# Technical Document LA24002XA

## Application for Amendment

<b>NRCB USE ONLY</b>	NRCB Application number	Date Stamp
<input checked="" type="checkbox"/> Approval <input type="checkbox"/> Registration <input type="checkbox"/> Authorization	<b>LA24002XA</b>	<b>NRCB APPLICATION RECEIVED 31 JAN 25</b>

Which permit do you wish to amend? (List permit number and issuing agency.)	AO Comment: Applicant is applying to amend NRCB Approval LA24002X. <i>LA 24002 N.R.C.B.</i>
Legal Land Description(s)	<i>SE 21-09-26 W4</i> (Qtr-Sec-Twp-Rg-W Mer)

FEED LOT LAYOUT  
PROPOSED PLAN & DETAILS

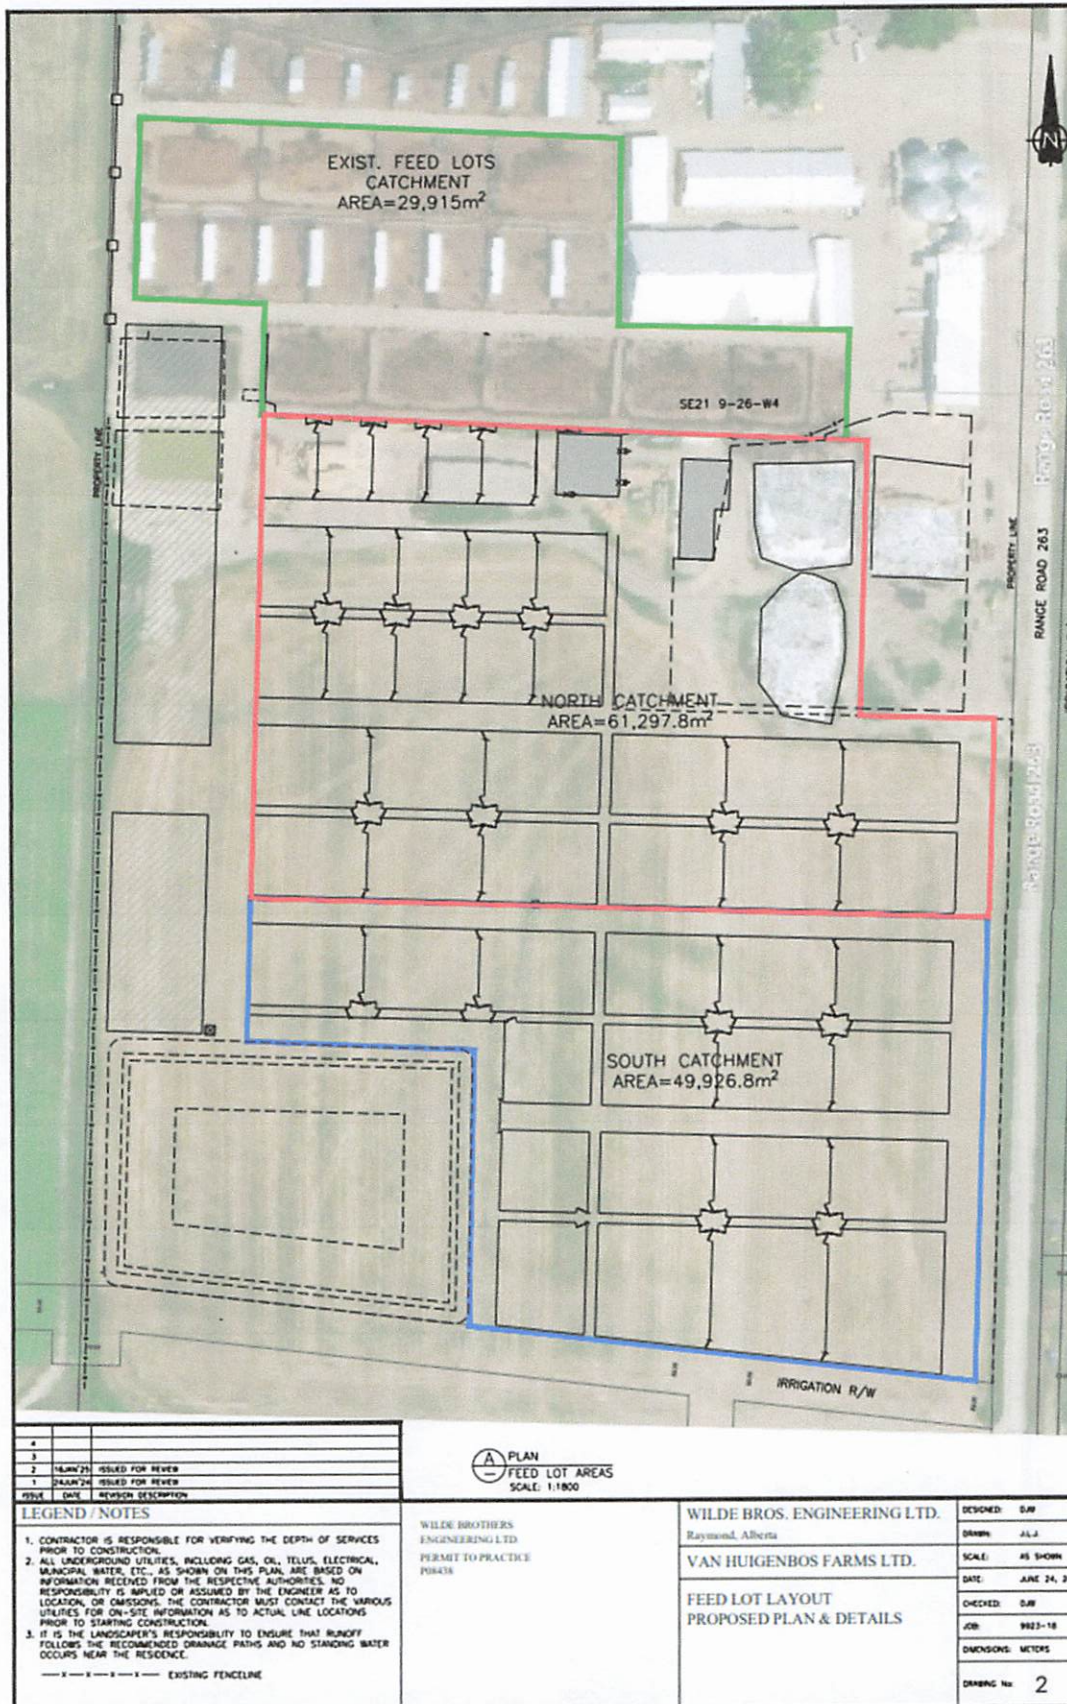
AO Comment: Updated site plan for areas contributing to run-off.

# Catch Basin Storage Volume Calculator

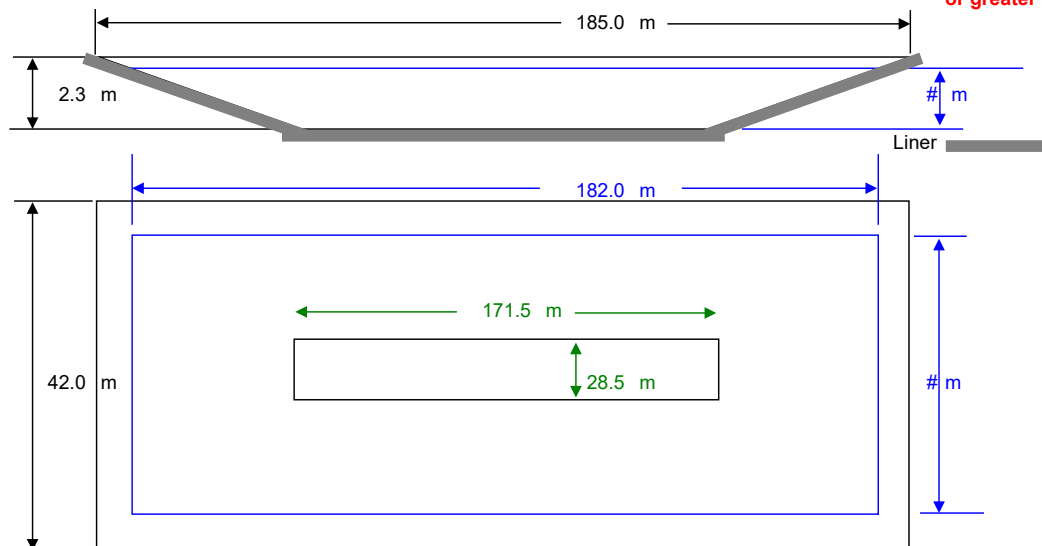
Total Length* <sub>4</sub>	185.0	m
Total Width* <sub>4</sub>	42.0	m
Total Depth* <sub>4</sub>	2.3	m
Design Capacity Depth	1.75	m
End Slope* <sub>4</sub>	3	run:rise
Side Slope* <sub>4</sub>	3	run:rise
Length of Bottom	171.5	m
Width of Bottom	28.5	m

Design Capacity (freeboard level) 10,455 m<sup>3</sup>

8,209 m<sup>3</sup> \*\* 289903.47 ft<sup>3</sup>  
1805760.3 Imp. Gal.

Catch basin calculator. Total volume @ freeboard level: 10,455 m<sup>3</sup> Runoff capacity requirements met: ☒ YES ☐ NO

# Catch Basin Storage Volume Calculator

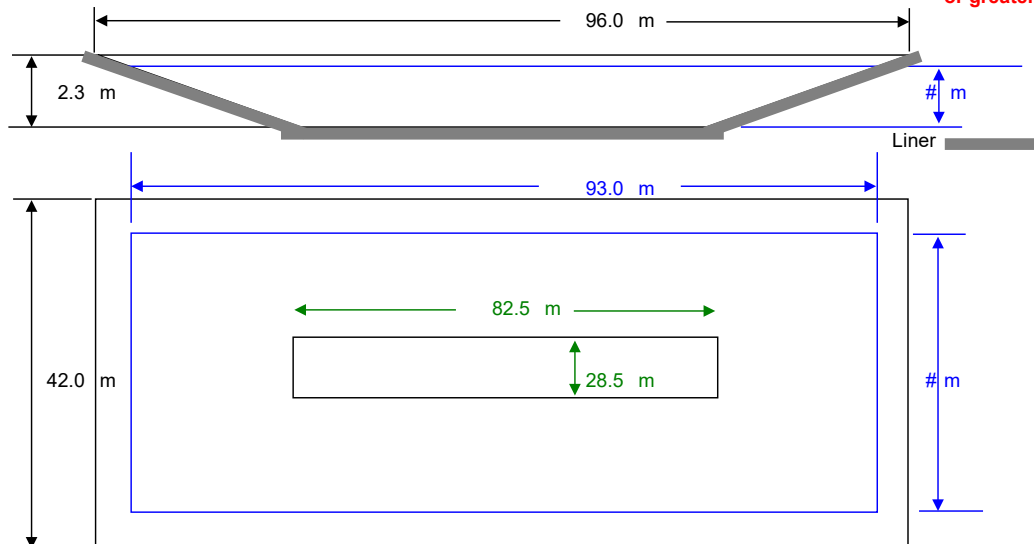
Total Length* <sub>4</sub>	96.0	m
Total Width* <sub>4</sub>	42.0	m
Total Depth* <sub>4</sub>	2.3	m
Design Capacity Depth	1.75	m
End Slope* <sub>4</sub>	3	run:rise
Side Slope* <sub>4</sub>	3	run:rise
Length of Bottom	82.5	m
Width of Bottom	28.5	m

Design Capacity (freeboard level) 5,199 m<sup>3</sup>

4,493 m<sup>3</sup> \*\* 158683.35 ft<sup>3</sup>  
988412.07 Imp. Gal.

Catch basin calculator. Total volume @ freeboard level: 5,199 m<sup>3</sup> Runoff capacity requirements met: ☒ YES ☐ NO
